CNL-22-075

Browns Ferry Nuclear Plant, Unit 2
Renewed Facility Operating License No. DPR-52
NRC Docket No. 50-260

Subject: **Response to Request for Additional Information Regarding Browns Ferry Nuclear Plant, Unit 2, Request for Alternative, BFN-21-ISI-02, Alternative to American Society of Mechanical Engineers, Boiler and Pressure Vessel Code, Section XI, Paragraph IWB-2420(b) and the Use of Case N-526 (EPID L-2022-LLR-0008)**

Response to NRC Request for Additional Information

Figure 3. Flaw geometry [6]

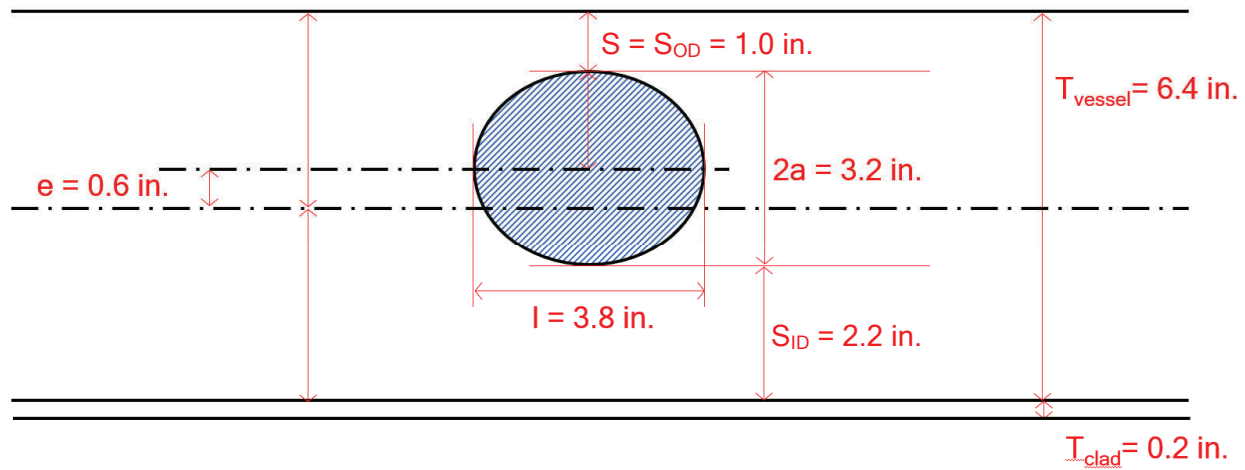
Additionally, TVA identified an administrative error in Attachment 1 of the enclosure to Reference 1 regarding location of the BFN V-3-A weld flaw after submittal to the NRC. Enclosure 2 to this letter provides a revised weld flaw assessment by Structural Integrity Associates (SI) with the corrected location, and this assessment replaces and supersedes Attachment 1 of Reference 1.

Revised Section 4.0, 1: Incorporated the correct elevation of the axial flaw per CAR 22-041.

1. The indication is reported as being subsurface, separated from the vessel base metal/clad interface by 2.2 inches [6]. The cross-flaw depth dimension in the vessel radial direction ($2a$) is 3.2 inches [6]. The flaw is in the vertical weld V-3-A at 107° azimuth, or 42.95 to 46.7 inches above the circumferential weld C-2-3 [6,7]. Details of the geometric parameters of the subsurface flaw are summarized in Figure 3.

Figure 6. Development of BFN Plant-Specific Proximity Rule

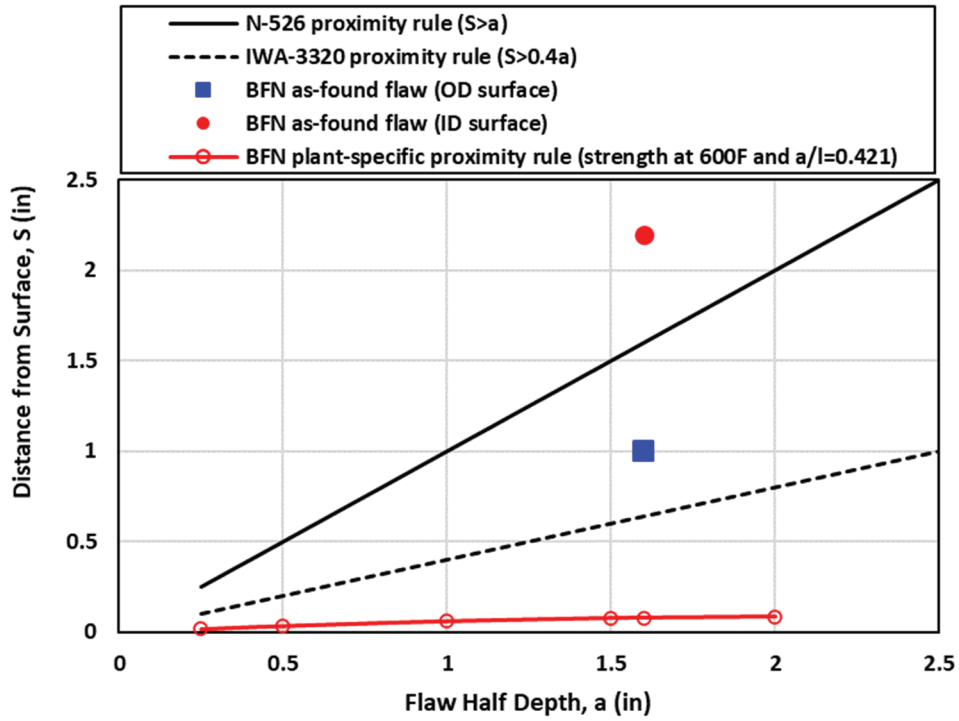
- (a) The flaw is characterized as subsurface in accordance with Figure 1.
- (b) The nondestructive examination technique and evaluation that detected and characterized the flaw, with respect to both sizing and location, shall be documented in the flaw evaluation report.
- (c) The vessel containing the flaw is acceptable for continued service in accordance with IWB-3600, and the flaw is demonstrated acceptable for the intended service life of the vessel.”

The proposed alternative request seeks to utilize ASME Code Case N-526 to eliminate the periodic re-examinations of the subject weld using an alternative to the proximity rules of Figure 1. Therefore, condition (a) of Code Case N-526 will not be met, instead using the subsurface characterization of IWA-3320 as noted in the proposed alternative. The statement in question is an attestation that the conditions (b) and (c) of Code Case N-526 have been met.

The as-developed plant-specific surface proximity rule has been applied on the observed flaw in the vertical weld of the BFN RPV. Using the plant-specific proximity curve, developed using the same technical evaluation methods as the Code Case N-526 curve, this graph demonstrates that the as-found flaw is still bounded by the Code Case N-526 technical basis, even when considering the flaw's proximity to the OD surface. As shown in Figure 6 (blue square marker), the minimum distance to the OD surface for the as-found flaw is 1 inch, and the half-flaw depth is $a = 1.6$ inch. The observed flaw (from OD surface) is above the as-developed plant-specific surface proximity curve in Figure 6 as discussed in Section 5.4 and therefore, it can be classified as a subsurface flaw for the purpose of applying Code Case N-526 successive examination exemption requirements. For completeness, the assessment of the observed flaw from the ID surface is also added in Figure 6 (red circle marker) where the minimum distance to the ID surface for the as-found flaw is 2.2 inch, and the half-flaw depth is $a = 1.6$ inch. This data point shows that the as-found flaw is acceptable per the existing conservative requirements of Code Case N-526, when the Code Case technical basis is applied, which would consider the flaw's proximity to only the ID surface. As seen in the figure, the observed flaw (from ID surface) meets the requirements of both the Code Case N-526 and as-developed plant-specific proximity rules to be classified as subsurface flaw.

- (a) The flaw is characterized as subsurface according to the as-developed plant-specific surface proximity rule (shown in Figure 6).
- (b) The NDE technique and evaluation that detected and characterized the flaw, with respect to both sizing and location, shall be documented in the flaw evaluation report.
- (c) The vessel containing the flaw is acceptable for continued service in accordance with IWB-3600, and the flaw is demonstrated acceptable for the intended service life of the vessel.

Figure 3. Development of BFN Plant-Specific Proximity Rule

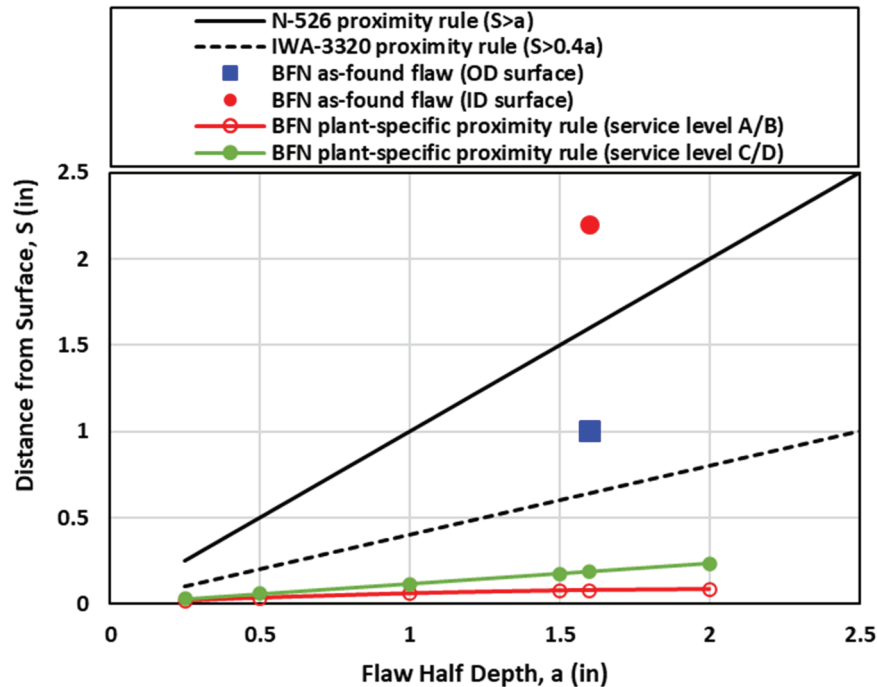
Discuss the applicability of all service loadings (i.e., normal, upset, emergency, and faulted) and any combination of them that were taken into consideration in the licensee's analysis in the submittal. Discuss whether loading conditions applicable to service levels C and D were considered in the licensee's analysis. If not considered, provide a justification for not considering the loading conditions applicable to service level C and D in the analysis in the submittal.

The results of the analysis in Enclosure 3 demonstrate that the plant-specific surface proximity curves for service level C/D loading is slightly higher than that for service level A/B loading (due to higher internal pressure for C/D loadings). However, each of these curves falls below both the IWA-3320 proximity rule and the Code Case N-526 surface proximity rule. Because the as-found flaw must meet the requirements of IWA-3320 to be considered as subsurface, the IWA-3320 rule ($S > 0.4a$) would be the plant-specific proximity rule for the as-found flaw under both service level A/B and C/D loadings.

- (a) The flaw is characterized as subsurface according to the as-developed plant-specific surface proximity rule (shown in Figure 3).
- (b) The NDE technique and evaluation that detected and characterized the flaw, with respect to both sizing and location, shall be documented in the flaw evaluation report.
- (c) The vessel containing the flaw is acceptable for continued service in accordance with IWB-3600, and the flaw is demonstrated acceptable for the intended service life of the vessel.

Figure 4: Stress Intensity Factor Comparison - Quarter-T Flaw Versus Weld V-3-A Flaw

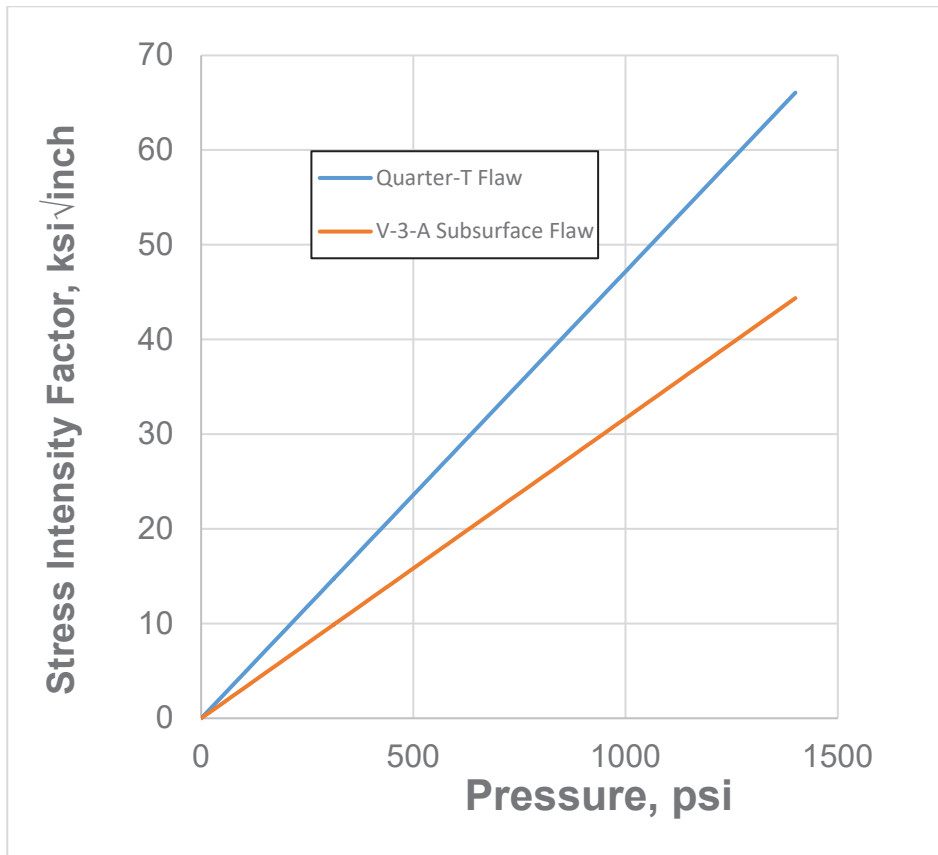
Discuss whether the flaw in weld V-3-A affects the existing P-T limit curves in the plant technical specifications. If yes, indicate when TVA plans to revise the P-T limit curves to reflect the impact of the flaw on the P-T limit curves in the technical specifications via a separate license amendment request.

Figure 4 shows the comparison of the Stress Intensity Factors for the two flaw types as a function of pressure. It is seen that the K_I solution for the Appendix G flaw bounds that for the weld V-3-A indication.
